LEGAL DESCRIPTION:
TRACT 1, CLIFFORD INDUSTRIAL PARK

ENGINEER'S SEAL	4455 ANAHEIM NE	DRAWN BY WCWJ
	GRADING AND DRAINAGE PLAN Rio Grande Engineering 1606 CENTRAL AVENUE SE SUITE 201 ALBUQUERQUE, NM 87106 (505) 872-0999	DATE 5-13-15
		SHEET # —
		JOB # 21515

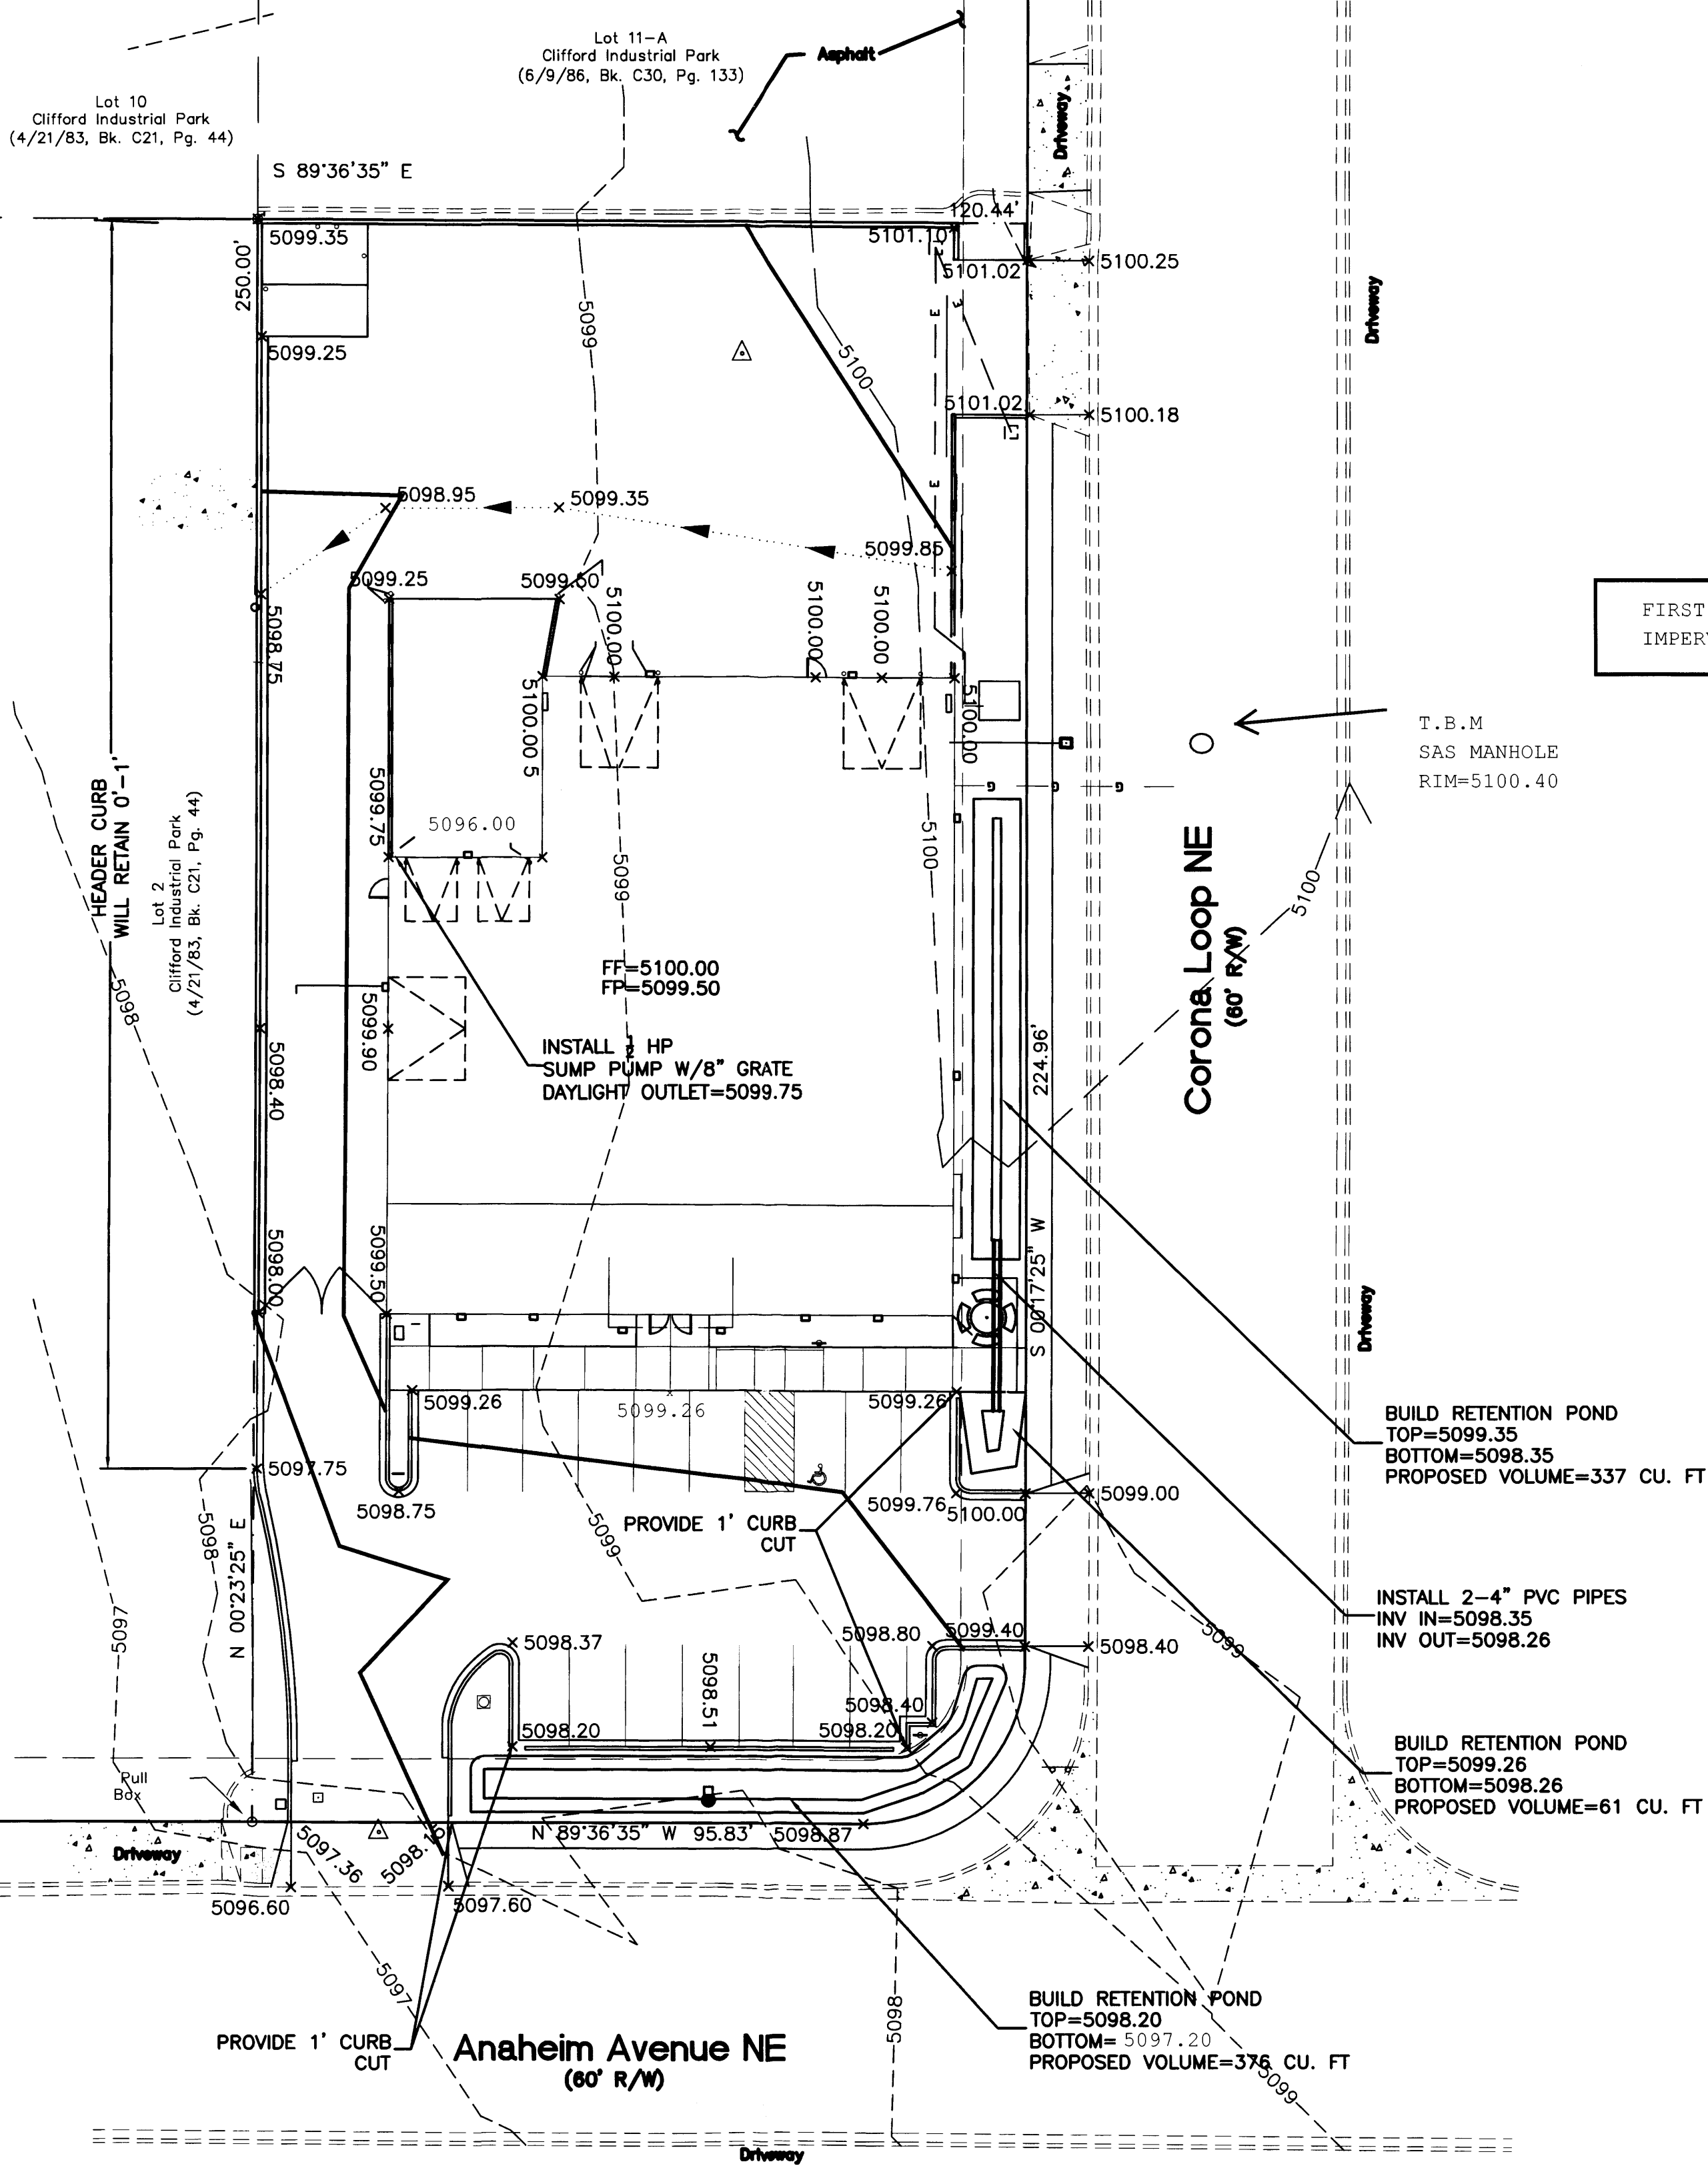
Label curb height as applicable.
Provide grade w/ property line curb
with 1/2" break in contour. Note
grade gravel base as applicable.
if effect.
If spot elevations are H/C
show roof drain locations
on curb spot elev.
Label proposed contours.
Indicate that "Retention
Ponds" are for first flush
if this is the case.
